Project: Arbor South (SP24-0011 – 2845 S. State Street) Re: Vehicular Use Area (VUA) Landscape Compliance and Request for Landscape Modification

Project: Arbor South (SP24-0011 – 2845 S. State Street) Re: Vehicular Use Area (VUA) Landscape Compliance and Request for Landscape Modification

Landscape Modification Requested for 5.20.3-B Landscaping (Interior Landscape Islands) related to VUAs

FOR 0-103

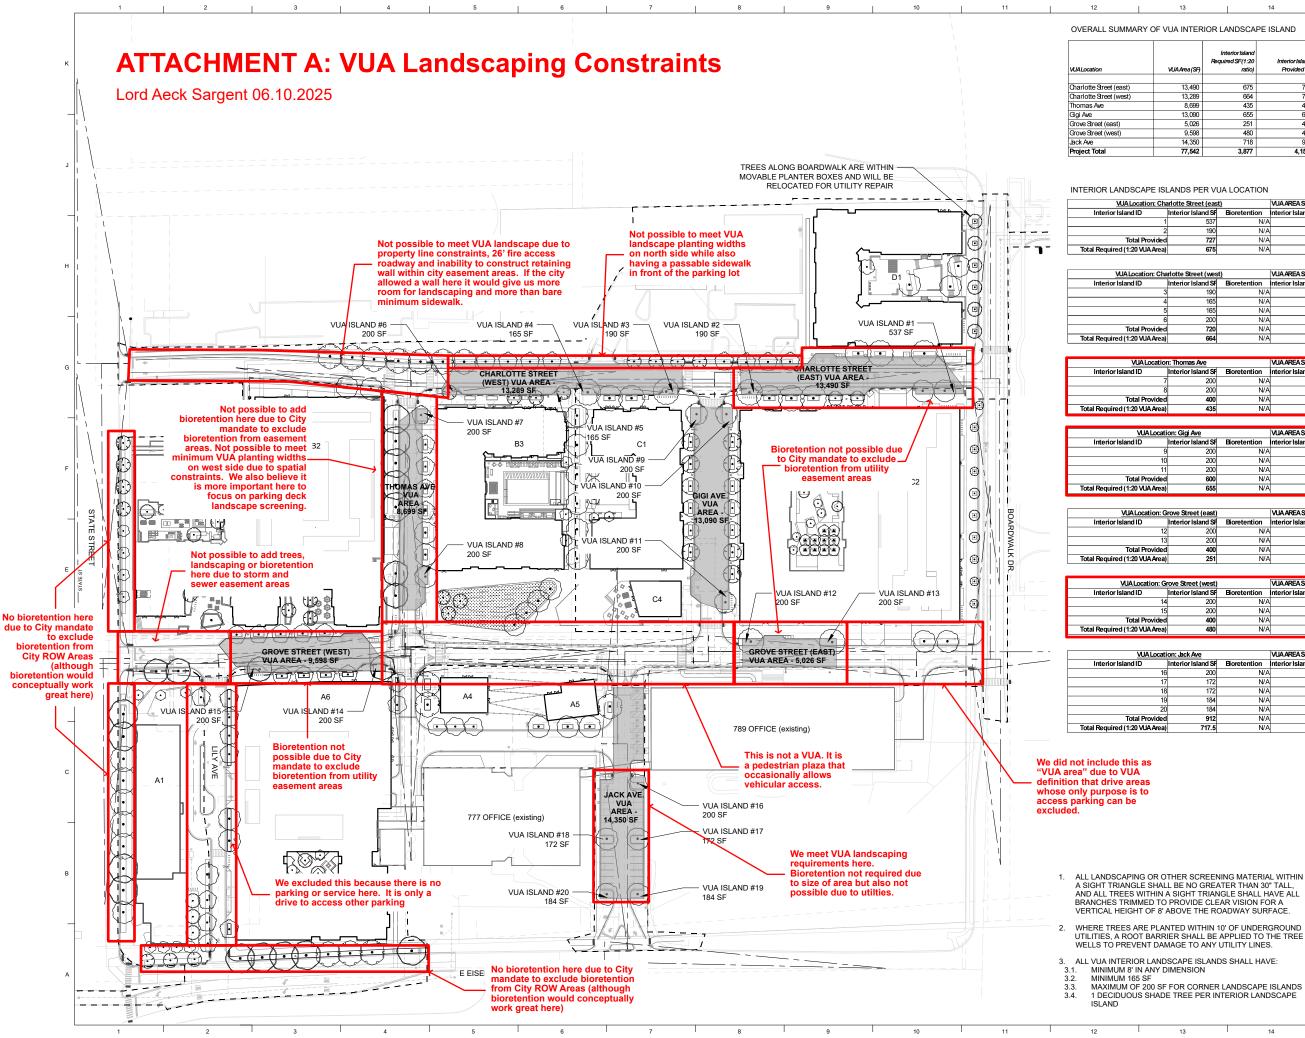
This understanding of the VUA code was our basis for VUA representation on Sheet LP0-103 in the 5/22/25 plan set. However, the city's subsequent review comments indicate a slightly different interpretation in addition to the request to add more VUAs to the plans. While certainly possible to add those areas to the plans as a formality we would not be compliant with VUA landscape requirements in any of those areas for the reasons described in *Attachment A.*

In my professional opinion it is absolutely not possible to create a VUA code-compliant landscape plan that <u>both</u> works within the physical constraints of Arbor South's existing conditions <u>while also</u> avoiding the large and widespread utility easement parameters required by the City. To give you specific examples, we recently identified (15) potential bioretention locations on this site based on anticipated hydrological patterns. We had to unfortunately remove all but (4) of those due to the City's mandate to exclude bioretention areas within utility easements or within existing City ROW areas. Despite our best efforts we similarly cannot fit trees or tree wells in many of the additional city-identified VUA areas due to pervasive underground utility conflicts and widespread utility easements across this site.

City Comment 4b: As the v4 Urban Forest Natural Resources Review has determined the proposed plans do not correctly identify the limits of the vehicular use area and do not provide the required landscaping per Section 5.20.3.B, revised plans are required.

City Comment 4b (con't): Alternatively, per Section 5.30.1, the Planning Commission may approve landscape modifications under certain circumstances. The project is eligible for landscape modifications because it is located in a special parking district (see 5.30.B.1.) If a landscape modification is desired provide a written statement addressing the sections or subsections for which a modification is requested, why it is being requested, the proposed alternative and how the alternative meets the intent of Section 5.20.1 Landscaping, Screening and Buffering.

We understand the request for landscape modification applies only to the VUAs identified on LP0-103 currently shown as <u>not compliant</u>, listed as follows.

- **Thomas Avenue** We are short only 35sf of interior landscape islands (5.20.3-B.1 Required Island Area). We are unable to add additional landscape islands due to extensive underground utilities and easement areas.
- **Gigi Avenue** We are short 55sf of interior landscape islands (5.20.3-B.1 Required Island Area). We are unable to add more additional landscape islands due to spatial limitations related to fire access and underground utility conflicts.
- **Grove Street (West)** We are short 80sf of interior landscape islands (5.20.3-B.1 Required Island Area). We are unable to add additional landscape islands due to extensive public storm and sewer easements as well as hydrant locations and required clearances around those.

LAS Response: As stated in yesterday's letter we believe we have correctly identified the limits of vehicular use area based on previous City comments, coordination meetings and our exhaustive reading of the code. Aside from seeing screenshots highlighting a few areas on the plan no explanation or detailed response on what exactly is incorrectly identified has been provided to us. We have reached out to the City for more info many times on this issue for over a year and have not received substantial clarity. If the City wants us to add more VUA areas we need more specificity, detail and guidance ideally a meeting. At this point I do not believe the written back and forth is productive on the specific issue of "correctly" identifying limits of VUAs.

- Thomas Avenue "Street" designed with street trees both sides spaced 30' o.c. typical. Along east side adjacent to on-street parking there tree wells at 6'x16' typical size (5'x15' typical planting area). Tree wells along on-street parking are set back 18" from face of curb and set within 6" ht "frame" to accommodate snow pile and help protect trees. Gaps between tree wells accommodate on-street parking access and protect trees from foot traffic. Along the west side fronting the exposed parking deck the design is a continuous 6'-wide tree planting strip along the curb in lieu of tree wells which allow for additional root growth and increased groundcover/shrub plantings. A continuous "tree buffer" strip is also proposed along the face of the deck to allow for additional screening. Trees along the west side of the street incorporate larger canopy and buffer-appropriate species to create a lush green buffer along the otherwise-exposed deck face.

- **Gigi Avenue** "Street" designed with street trees both sides spaced 30' o.c. typical. On-street parking along both sides to support resident guests and create "teaser" retail parking. Tree wells on both sides at 6'x16' typical size (5'x15' typical planting area). Tree wells set back 18" from face of curb and set within 6" ht "frame" to accommodate snow pile and help protect trees. Gaps between tree wells accommodate on-street parking access and protect trees from foot traffic. Typical tree spacing interrupted in cases where accommodating wider ADA parallel parking and at intersections with sight triangle limitations and/or with pedestrian crossings needing additional safety and visibility.

- Grove Street "Street" designed with street trees both sides spaced 30' o.c. typical. On-street parking on both sides in areas adjacent to ground floor retail. Tree wells on both sides at 6'x16' typical size (5'x15' typical planting area). Tree wells set back 18" from face of curb and set within 6" ht "frame" to accommodate snow pile and help protect trees. Gaps between tree wells accommodate on-street parking access and protect trees from foot traffic. Typical tree spacing interrupted in cases where accommodating wider ADA parallel parking and at intersections with sight triangle limitations and/or with pedestrian crossings needing additional safety and visibility. Within roughly 130' of the State Street intersection "street" trees cannot be accommodated due to large underground sewer line. In this case additional trees are added to adjacent courtyards and retail amenity spaces to bolster the future canopy.
